Re: [REDACTED]

Subject: Manufactured truss layout sheet 1, dated October 1, 2018 and structural calculations for manufactured trusses, dated October 1, 2018, all by Truss Engineering, Inc.

PUER18-445 PC1

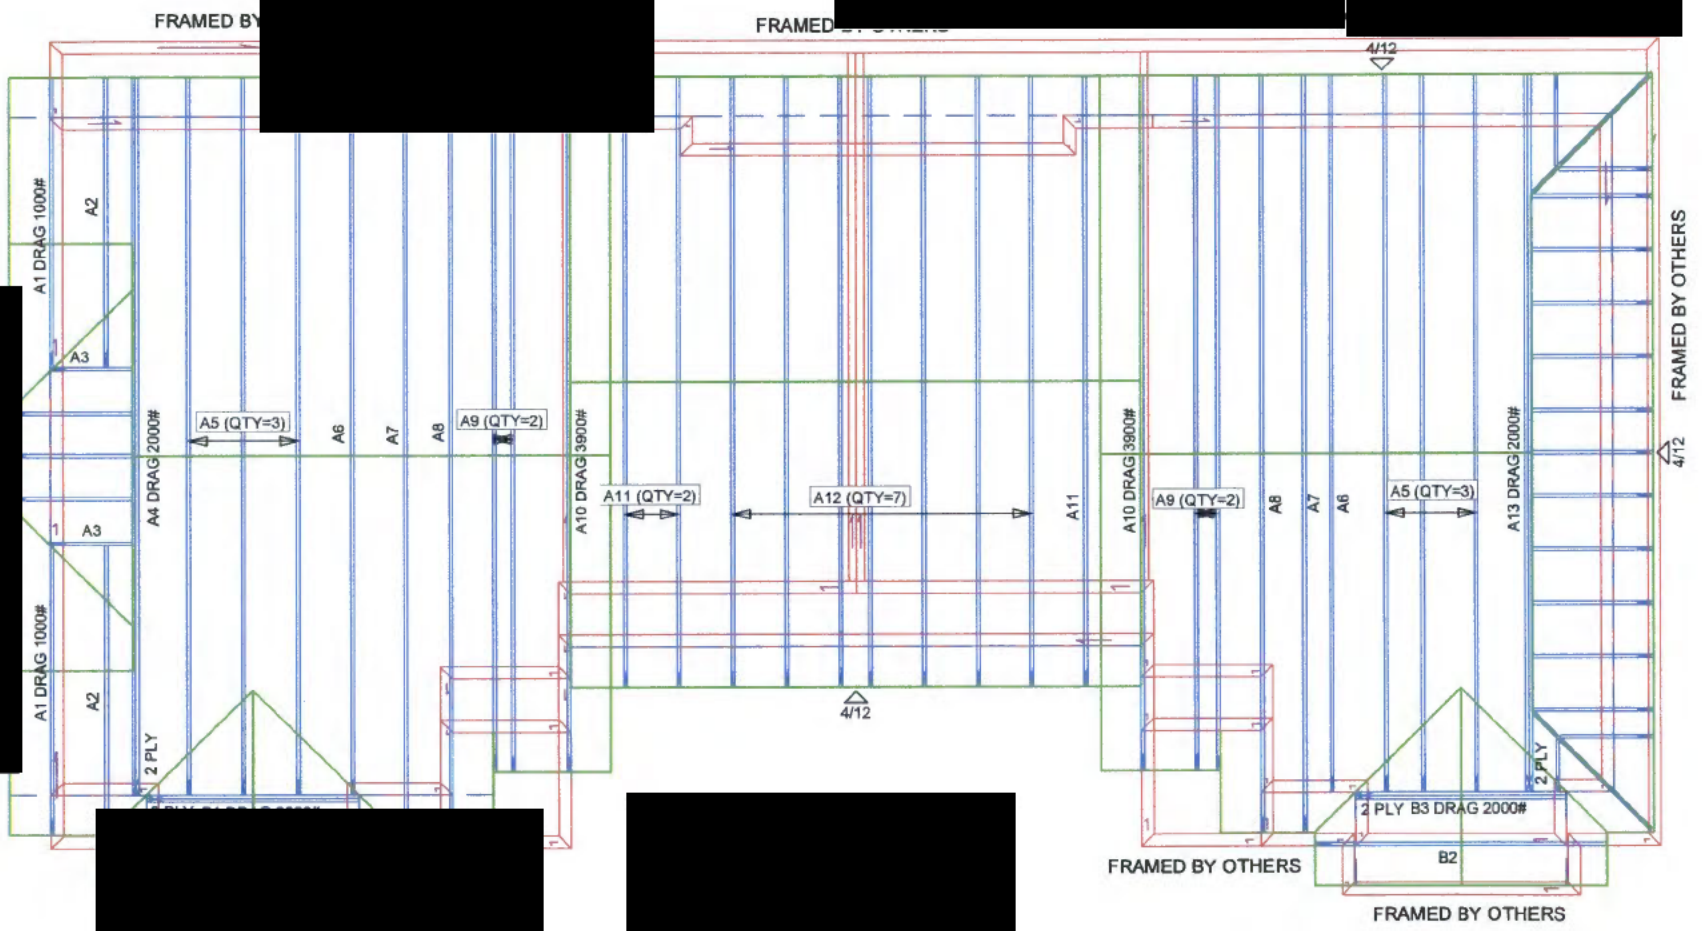
Note:  
 structural EOR review letter attached. Trusses are listed on the  
 cover sheet as a deferred approval item. These are to be submitted  
 to the City for review and approval prior to fabrication.
